**RE: Kassam Legacy Uptown Apartments – Phase 1
Permanent C.O. – Accepted
Engineer’s Certification Date: 11/30/23
Engineer’s Stamp Date: 10/29/19
Hydrology File: J18D033**

**WAIVER APPLICATION FROM STORMWATER
QUALITY VOLUME MANAGEMENT ON-SITE**

RE: Kassam Legacy Uptown Apartments | CPN 660082

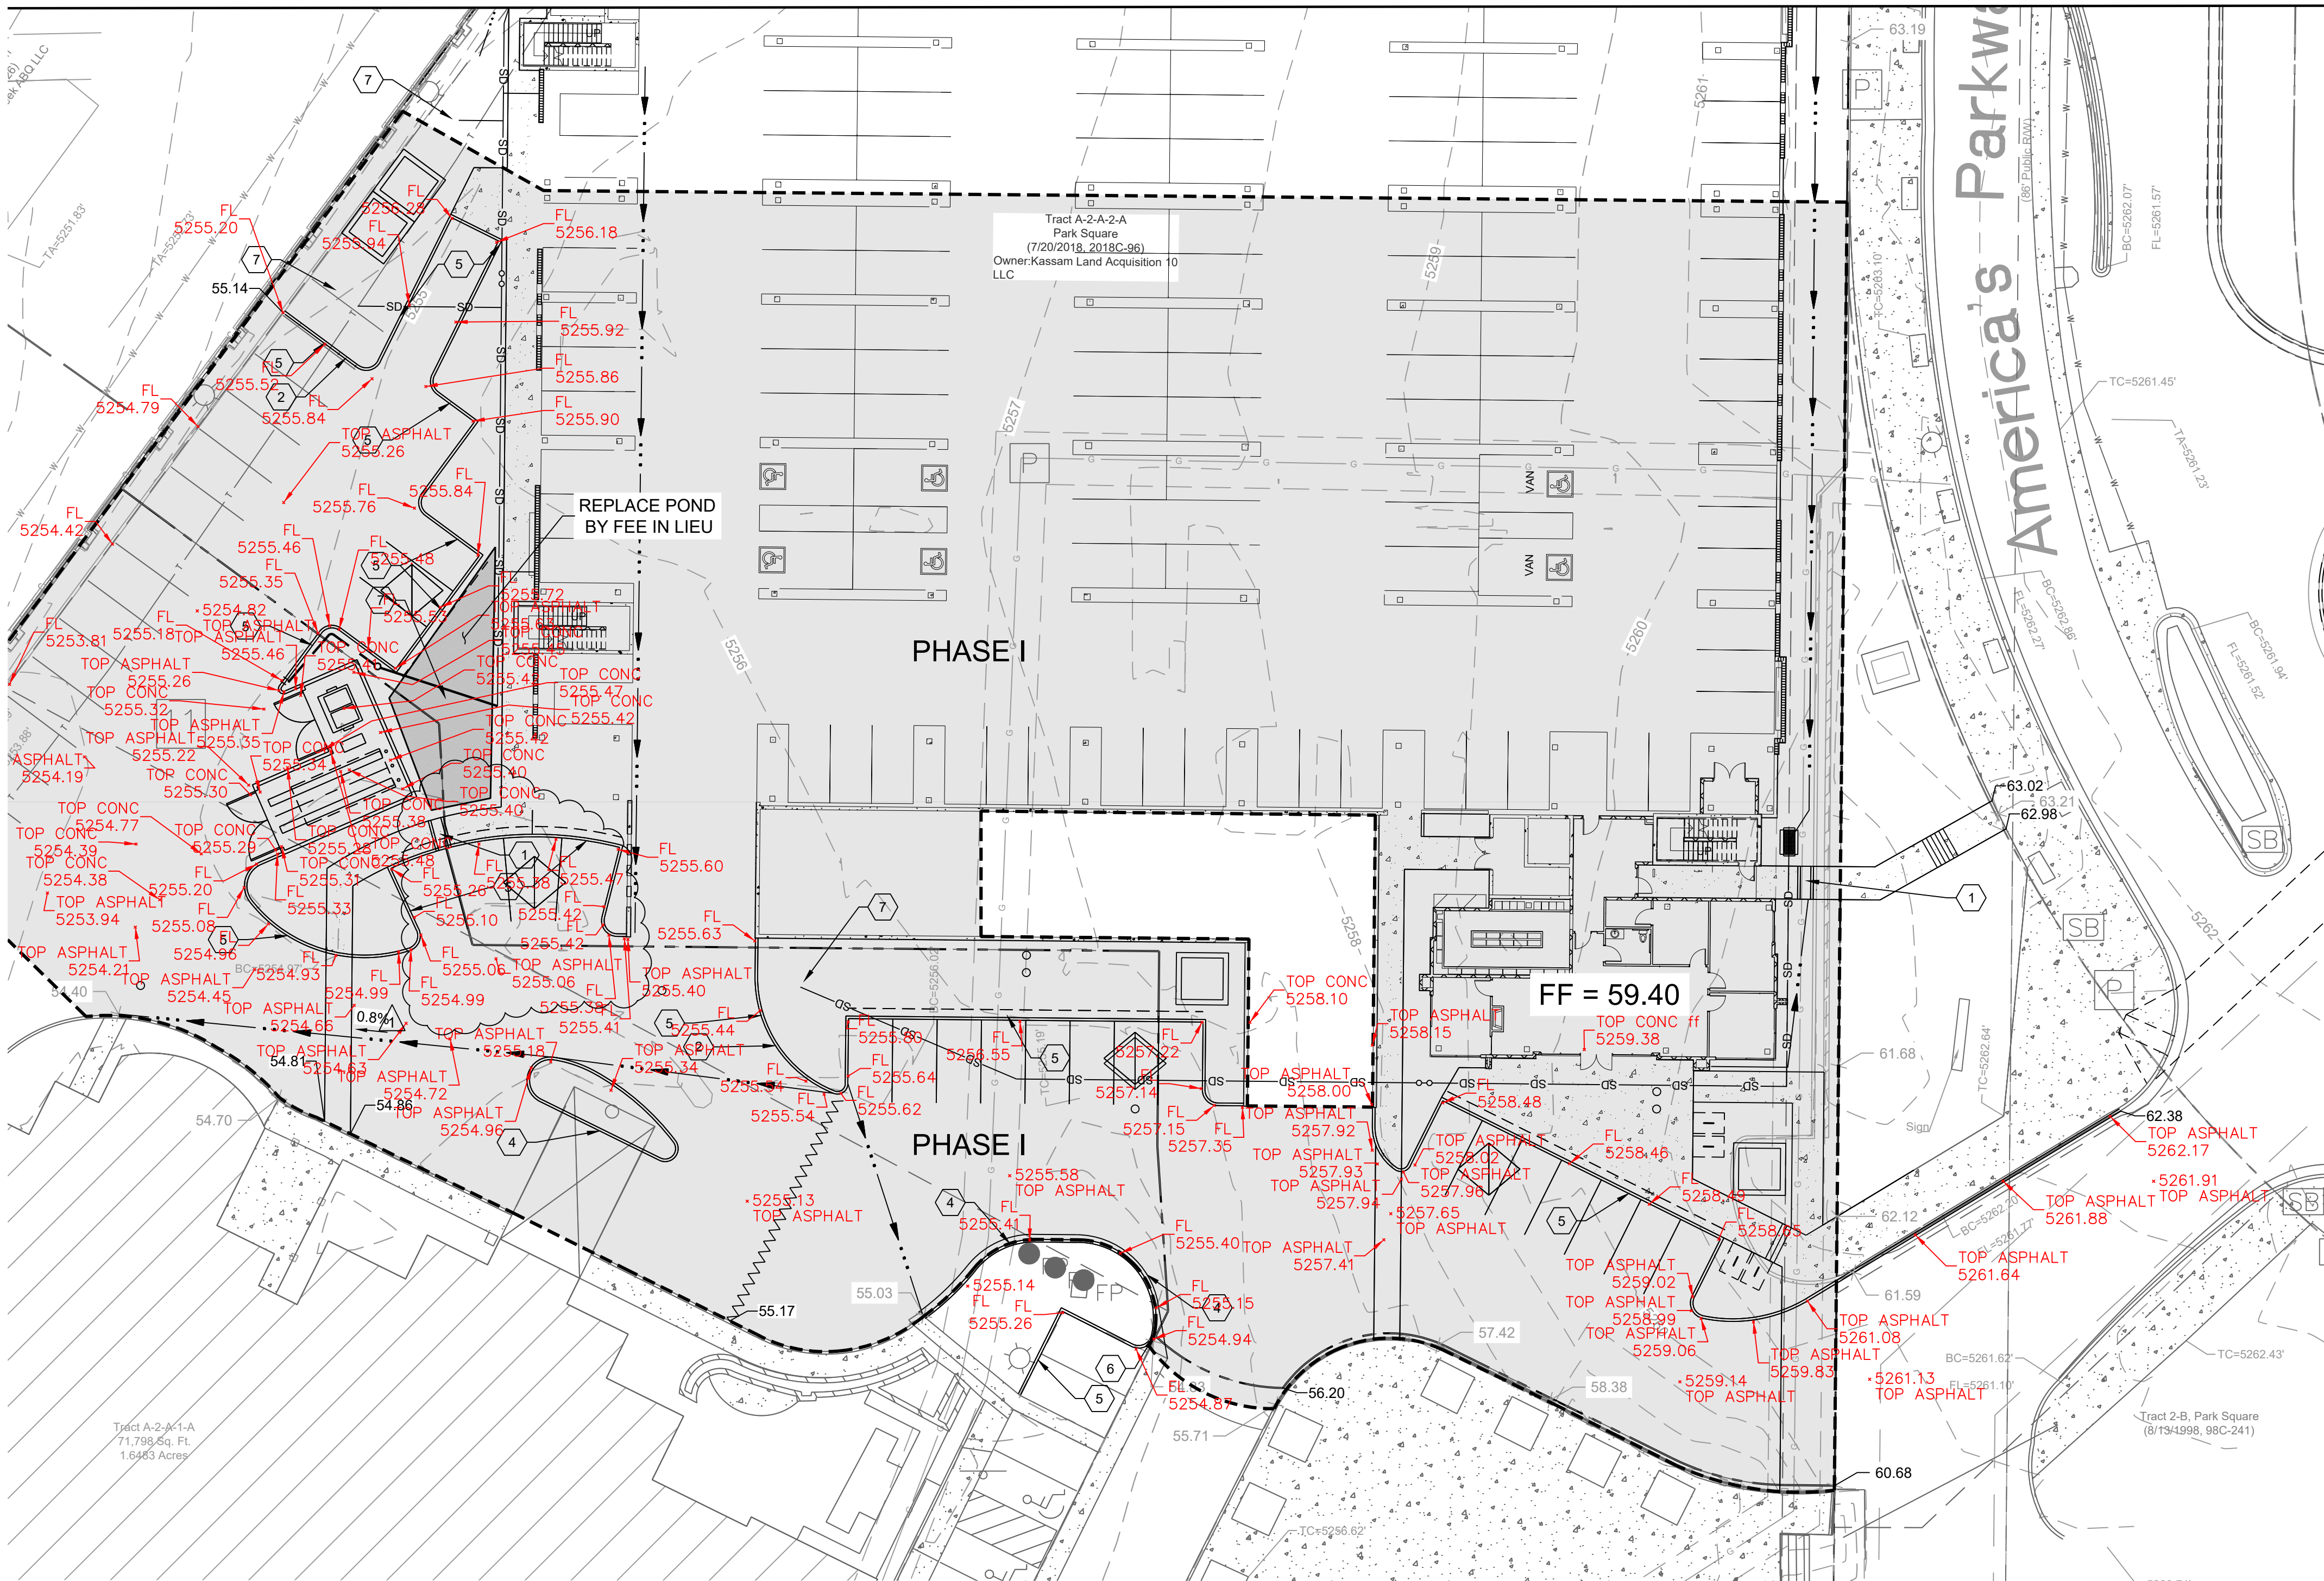
This site is a re-development that is part of a parking lot in the existing condition. The parcel is bounded on all sides by paved parking areas and roadways. Within the parking area we must maintain vehicular cross-lot access for adjacent parcels. Consequently, the grading design is highly constrained. The approved site plan shows a dog park where the WQ3 pond is located. This dog park was approved on the site plan and is in conflict with the WQ3 water quality pond. We will be capturing the appropriate stormwater and discharging it as shown on the enclosed exhibit.

I respectfully request that this waiver application be approved, allowing payment-in-lieu for the required stormwater quality volume. Your consideration in this matter is greatly appreciated.

DRAINAGE PLAN

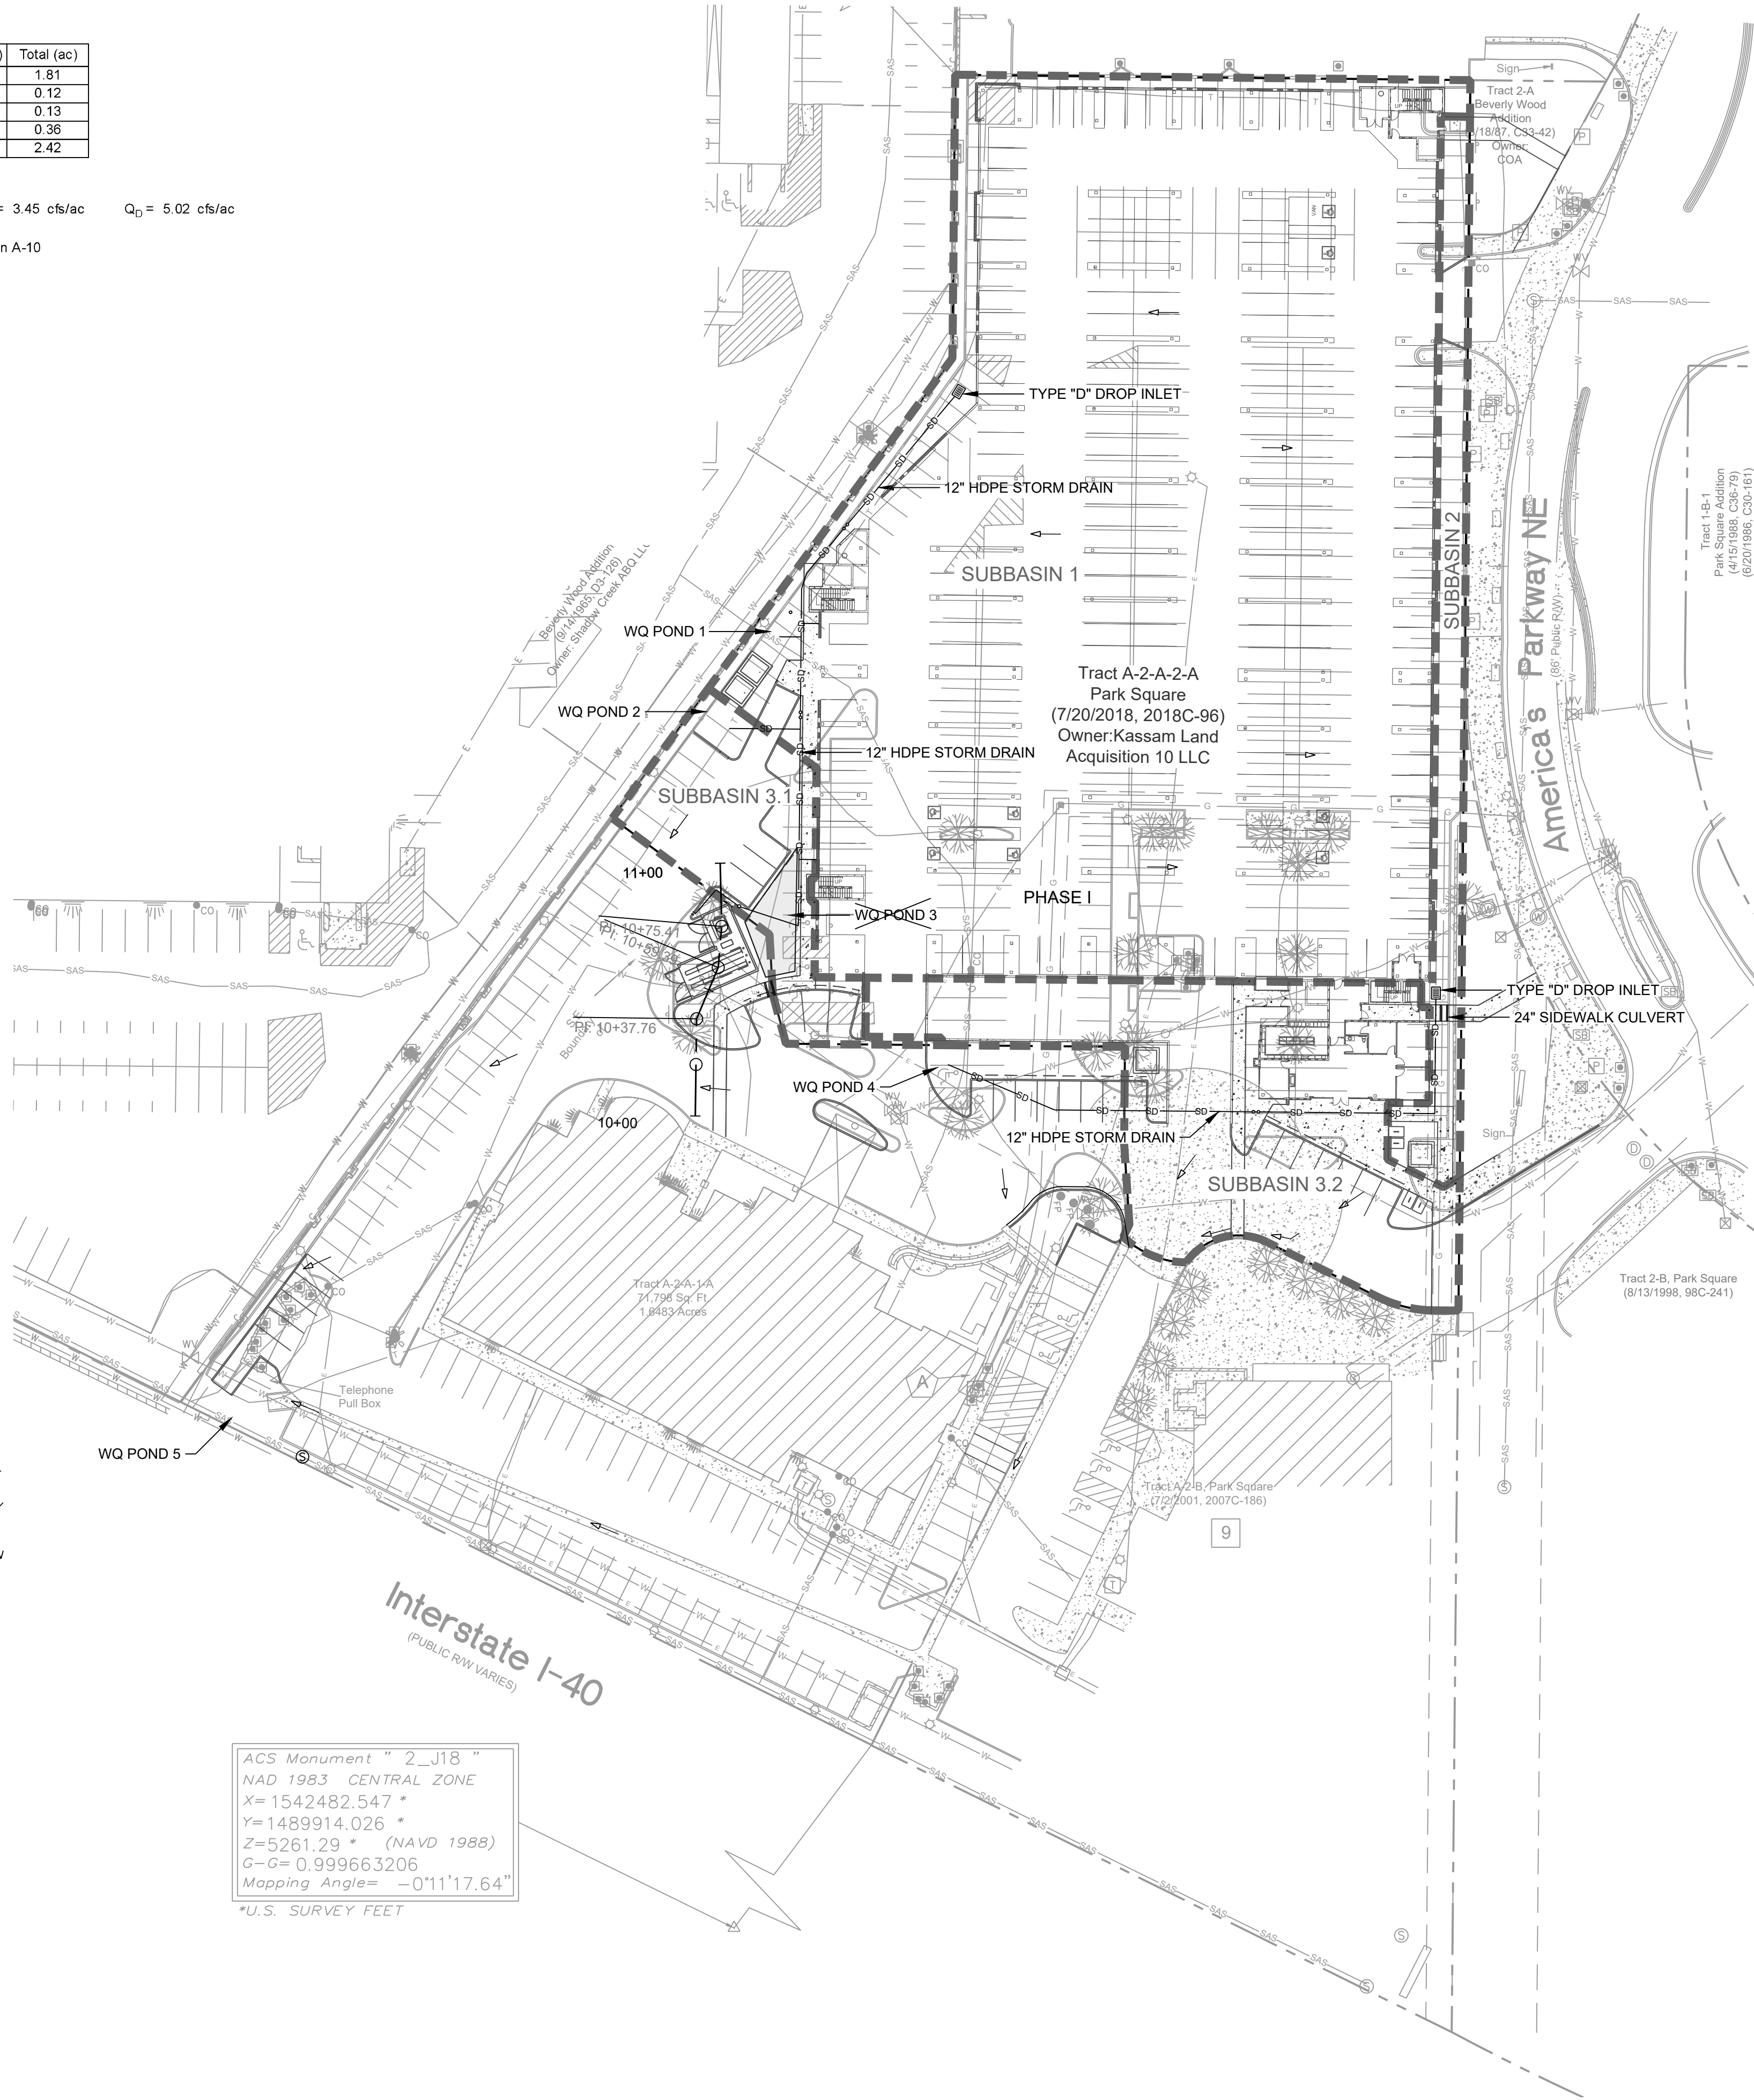
REPLACE
WQ POND 3
WITH FEE
IN LIEU

THE TOTAL REQUIRED STORMWATER QUALITY VOLUME FOR THIS DEVELOPMENT IS 2,595 CF. THE TOTAL STORMWATER QUALITY VOLUME PROVIDED IS 1,811 CF. THE OWNER HAS ELECTED TO PAY THE PAYMENT IN LIEU FOR THE REMAINING VOLUME OF 784 CF. THIS PAYMENT AMOUNT = 784 CF X \$8/CF = \$6,272.00.
